**TOWN OF DENTON
4 N. 2nd STREET, DENTON, MD 21629**

CROUSE PARK BULKHEAD RENOVATION

ADDENDUM 02

February 6, 2026

| <u>CONSTRUCTION PLAN</u> <u>TIMBER BULKHEAD</u> <u>DANIEL CROUSE MEMORIAL PARK</u> <u>DENTON, MARYLAND</u> | | |

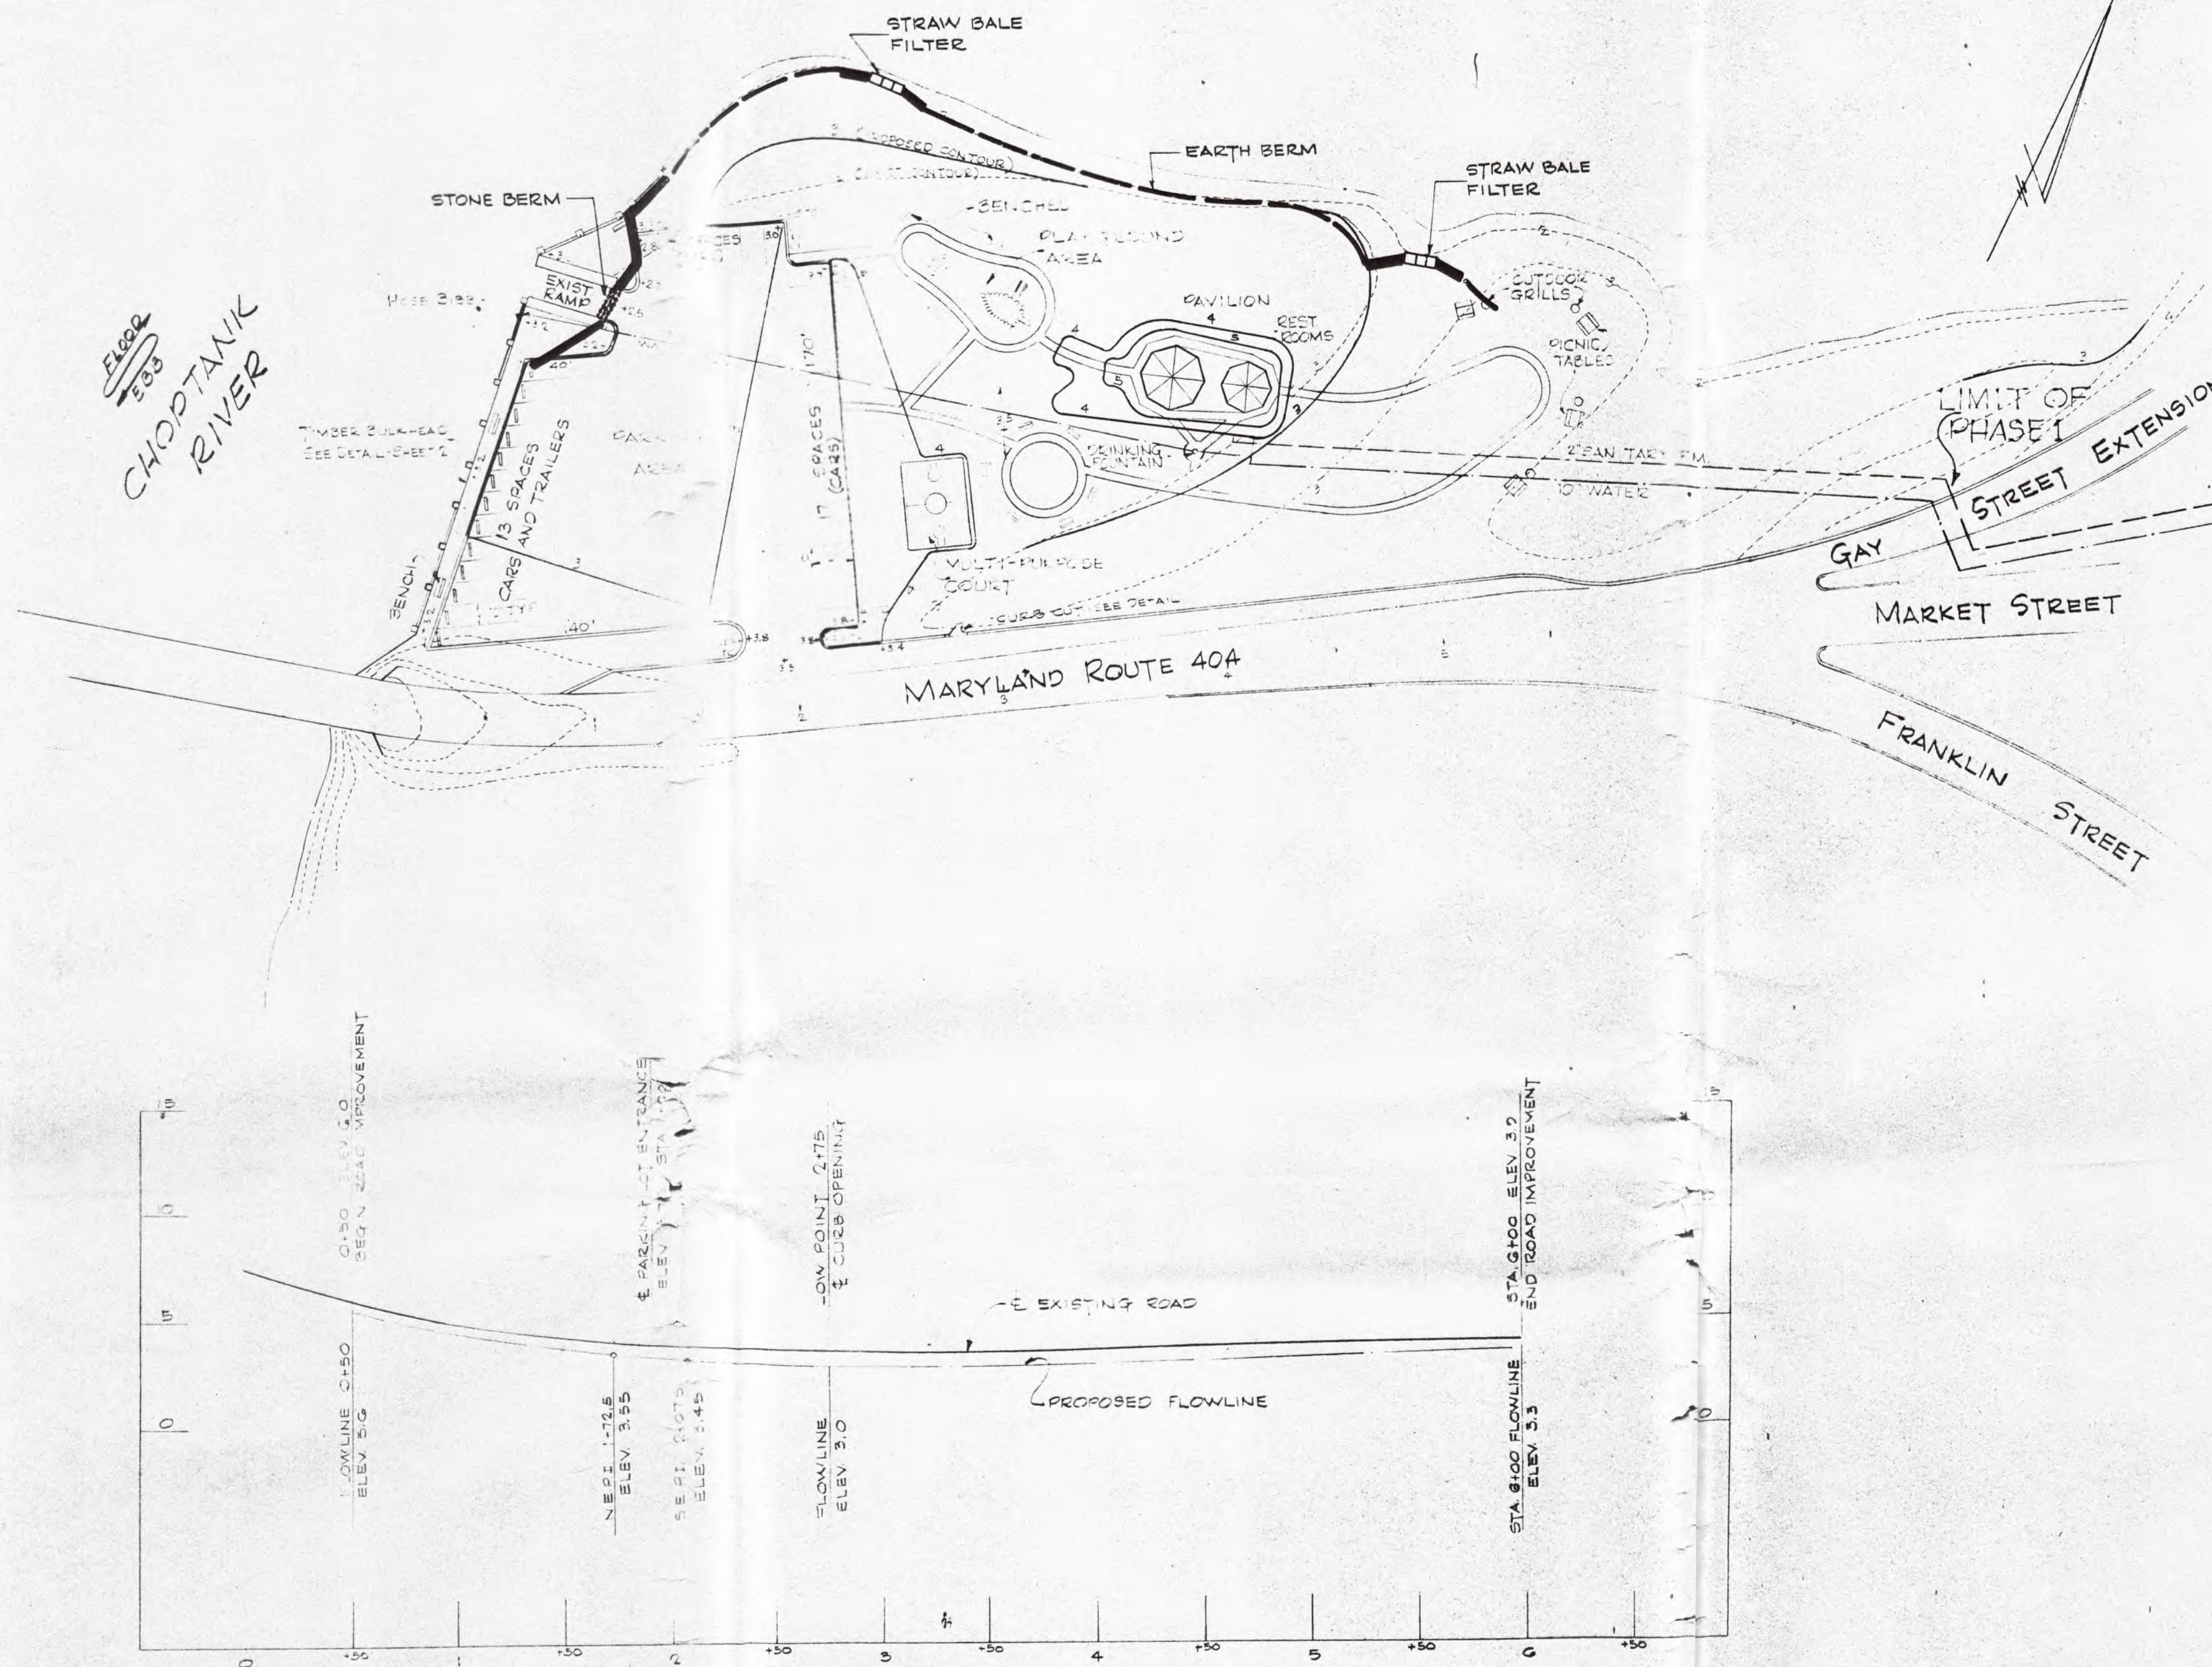
5. Question: Is the existing concrete deadman continuous or segmented?

6. Question: Are there any "as-built" drawings for the portion of the existing bulkhead to be replaced in-location?

Response: Per the previous drawings (attached) the dead man is continuous. The Town dug up one of the tie rods back at the deadman prior to bid and confirmed it was a timber deadman at that location. For reference and consideration, they encountered significant stone backfill while exposing the existing tie rod and deadman.

Response: Crouse Park Existing Drawings are included in the addendum for reference.
